ADDENDUM NUMBER 06

NEW LEGISLATIVE PARKING GARAGE

DIVISION OF PUBLIC WORKS PROJECT NUMBER 81284

May 16, 2024

sheet no.
C5.01

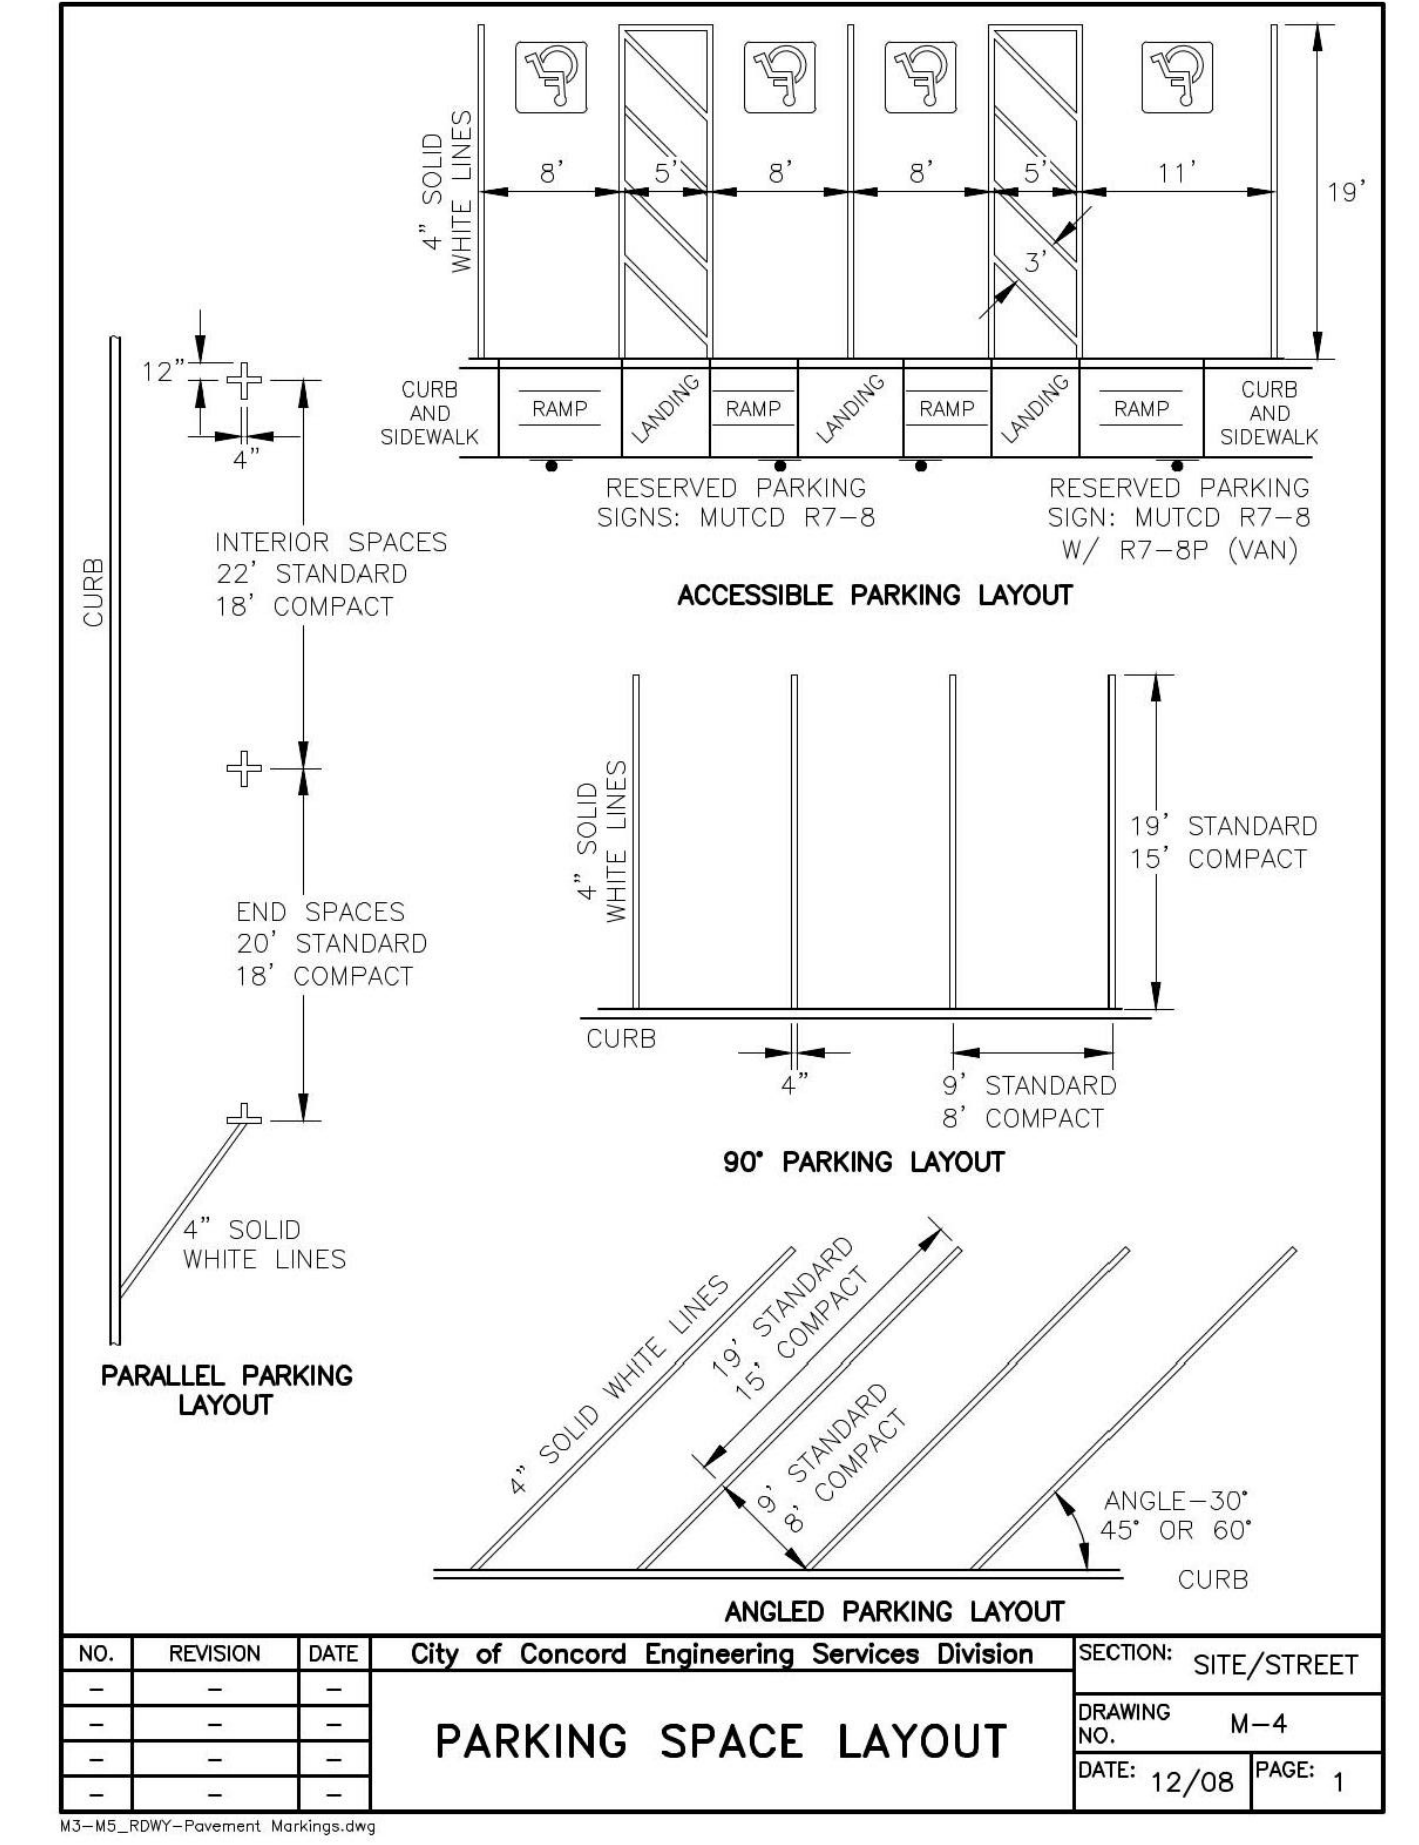
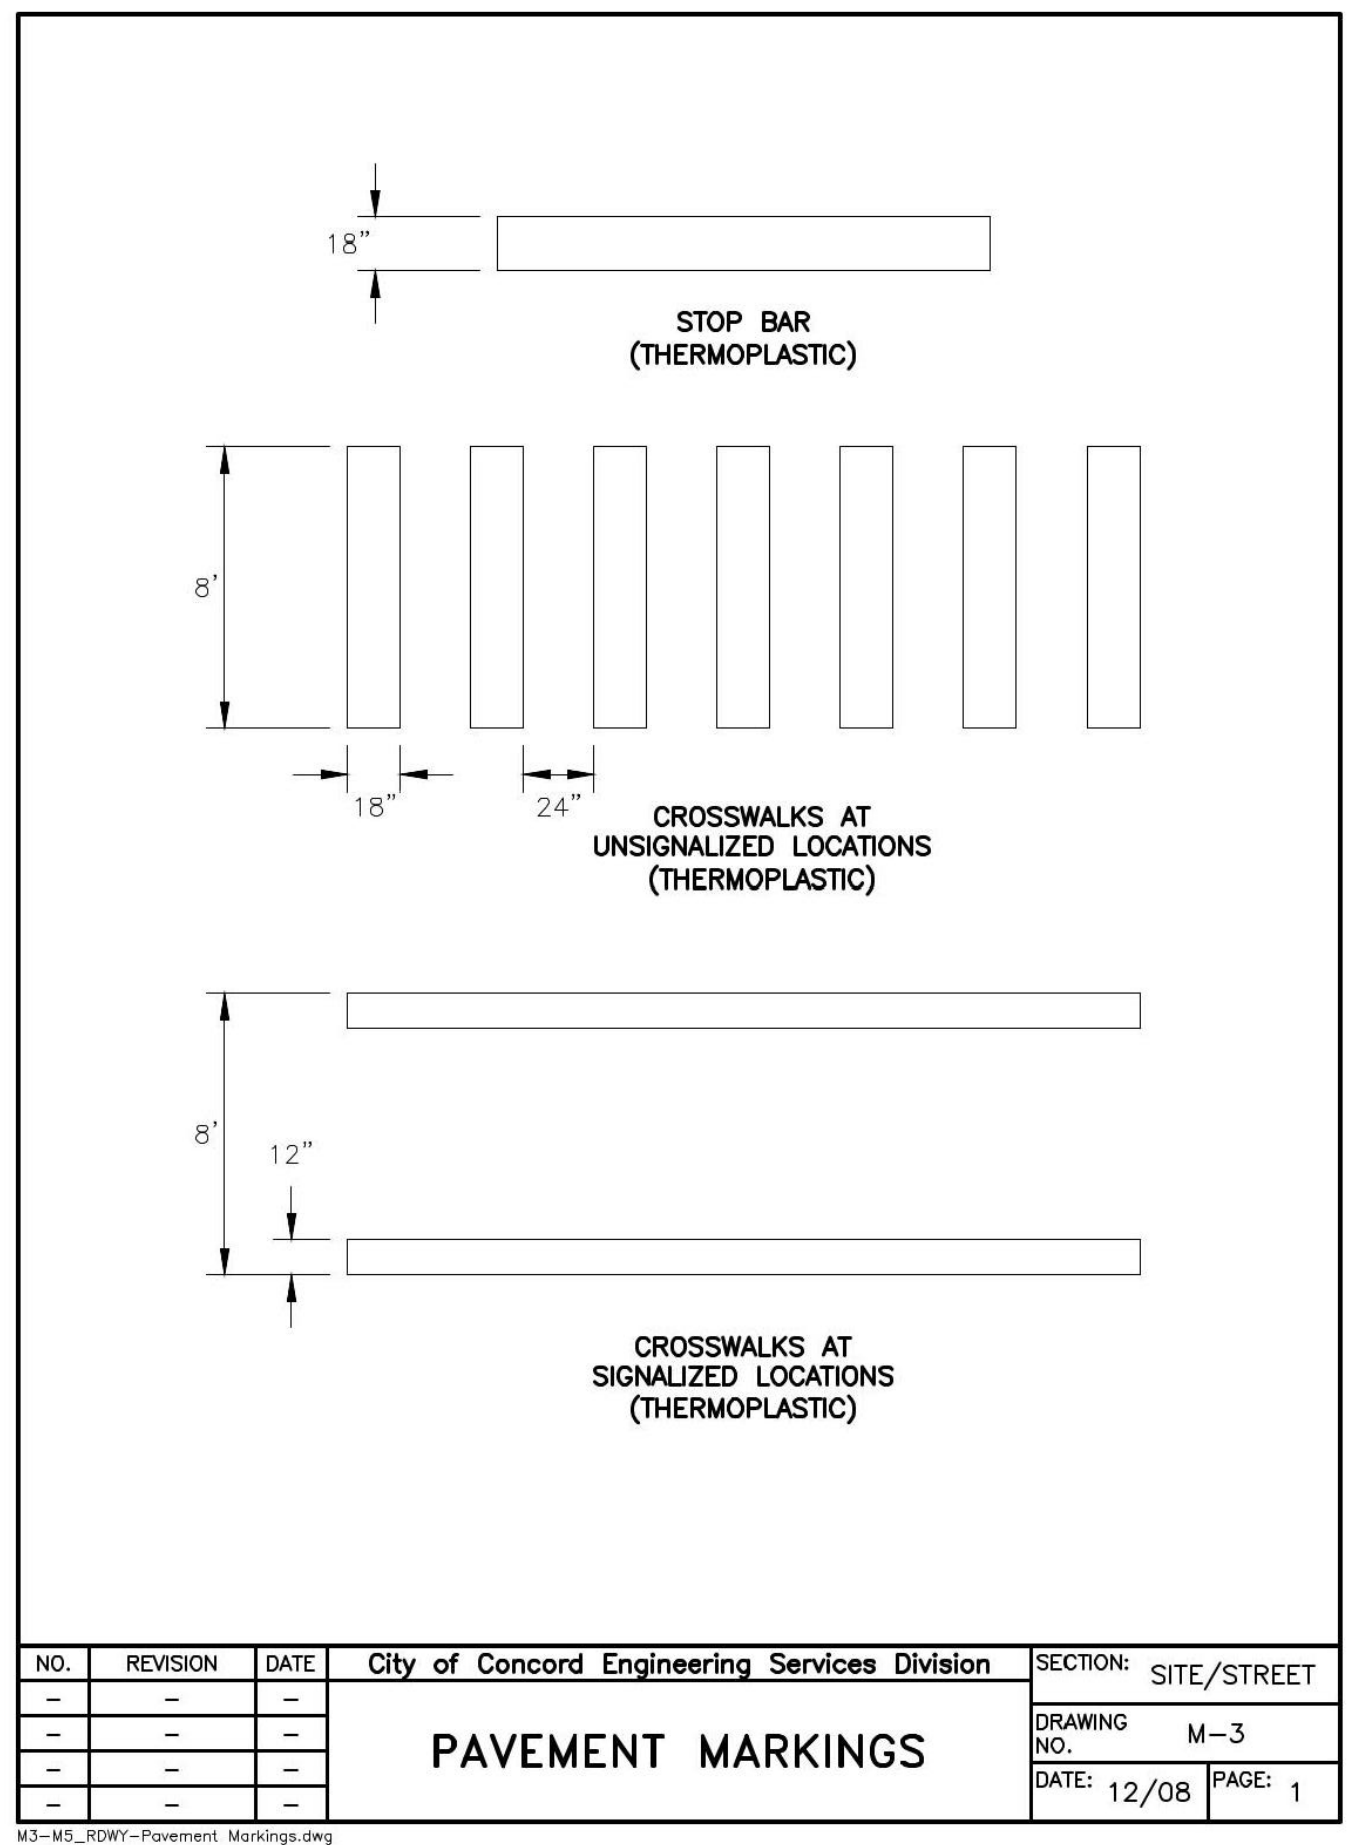
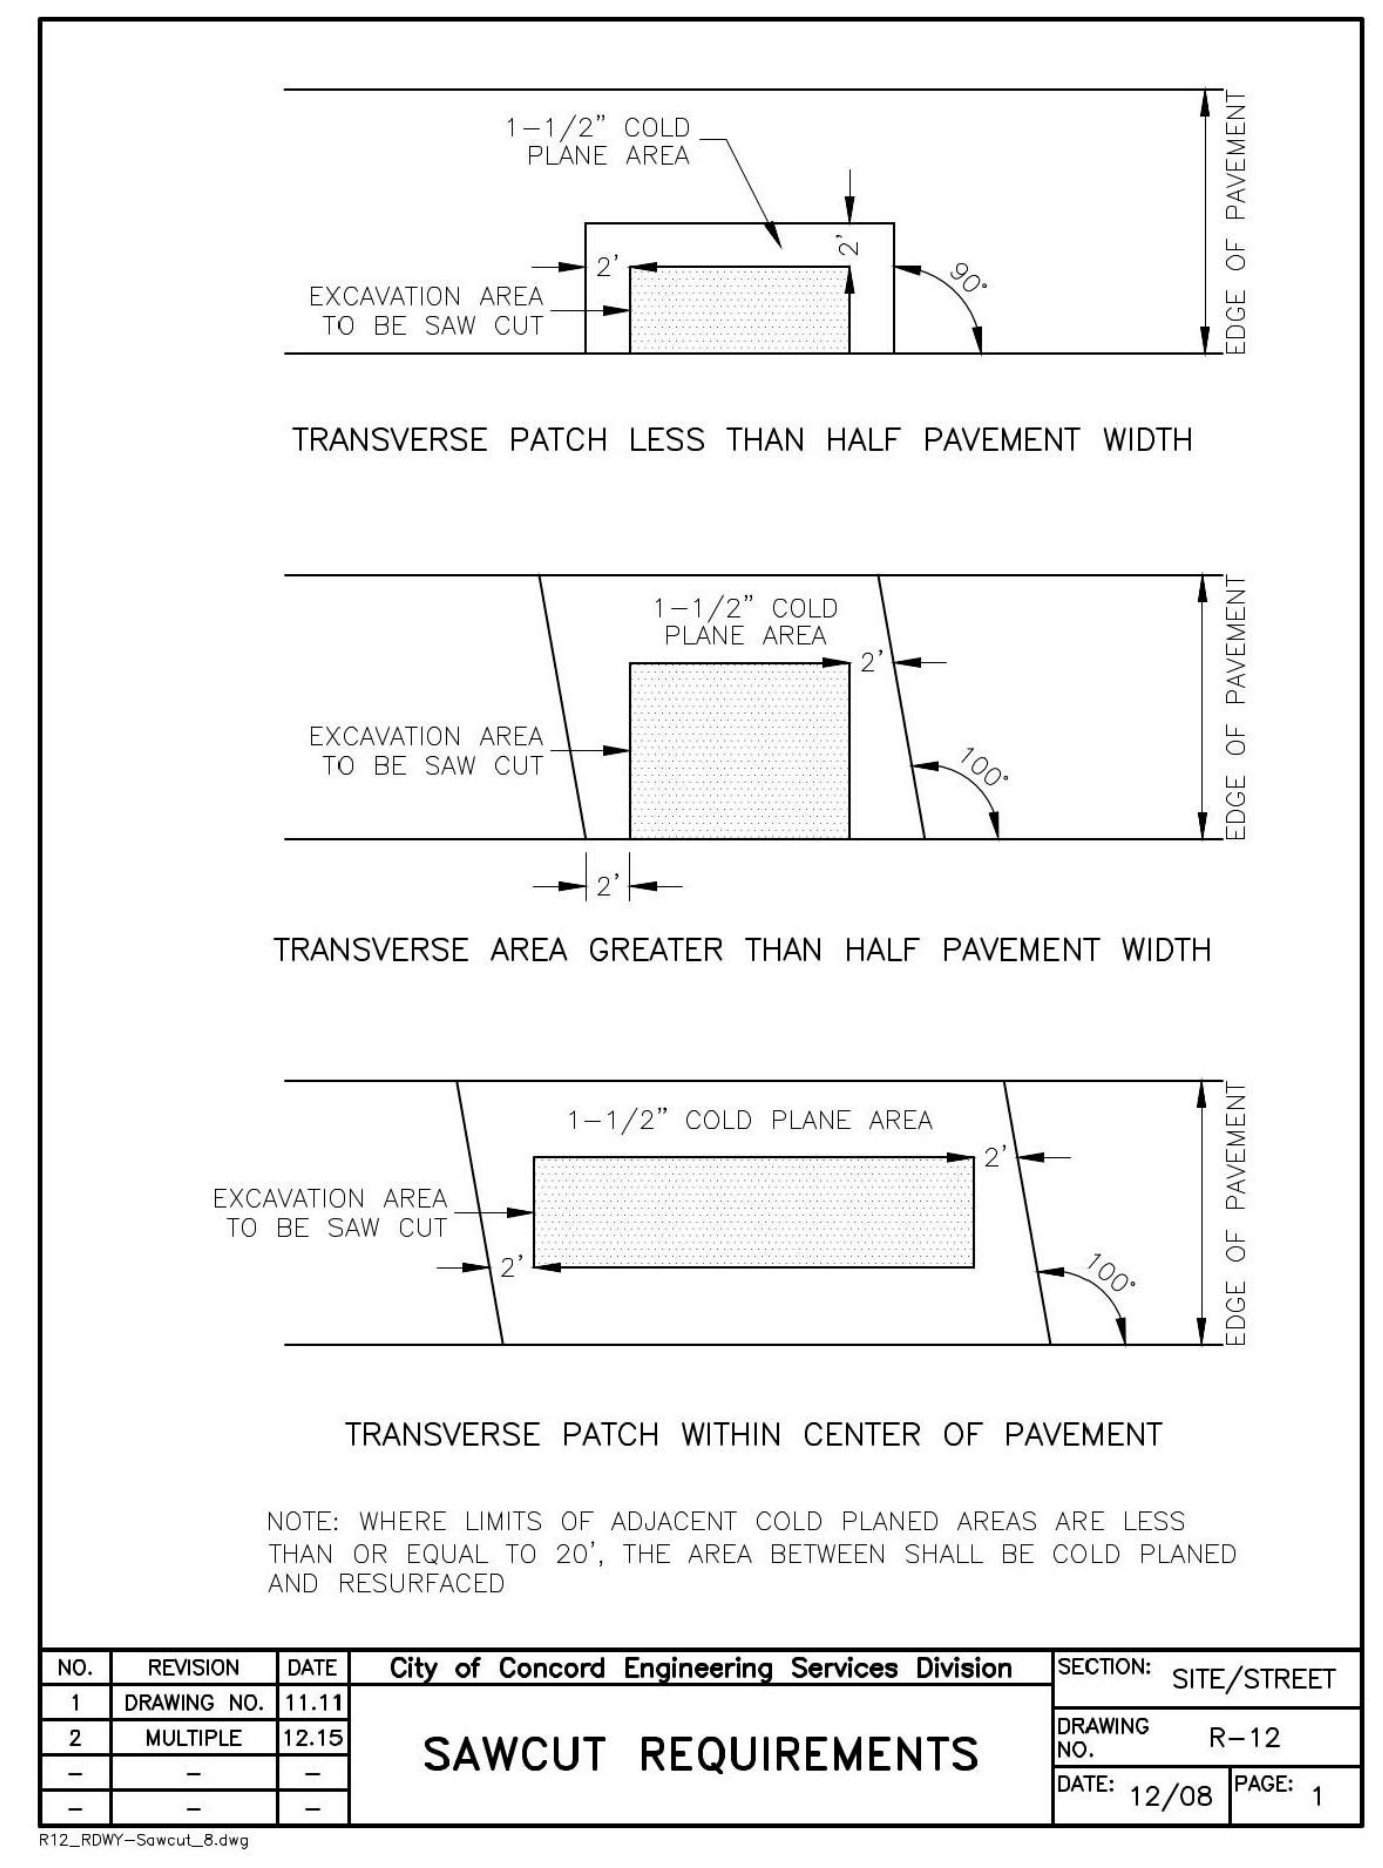
2. Q: The roadway paving detail 1/C5.01 indicates the final wearing course is to be paved by others. Is this the case? If this is the case, are structures within these areas be left 1.5” above grade? For the bid alternate, will this final paving course be by others according to 1/C5.01?

3. Q: In reference to Q&A #1 on Addendum #3 regarding parking garage asphalt thickness, the city street asphalt section is called out to be 5.5” thick of asphalt. Please confirm that 5.5” of asphalt is to be

placed on 1st floor of parking garage. In the detail, it also references top coat to be by others so where does that come in to play with the garage asphalt?

A. Street paving final wear course will be by others: Depending upon construction sequencing, the contractor shall either install the rim elevations to finished grade elevation (as they are currently shown within the plan set), or shall install the rims 1.5" below finished grade. Contractor to coordinate with the City of Concord to determine this elevation, but shall provide the flexibility for all proposed structures to be raised or lowered by utilizing a minimum of (2) courses of brick, and a maximum of (5) courses of brick per the City of Concord Standard Details.

B. Paving within the garage (bid alternate): No paving within the garage for the bid alternate will be performed "by others." Please see the revised Sheet C5.01.

A. Yes, 5.5” of asphalt is called for in the bid alternate for pavement in the garage. Please see response to question 2 above and reference revised sheet C5.01.
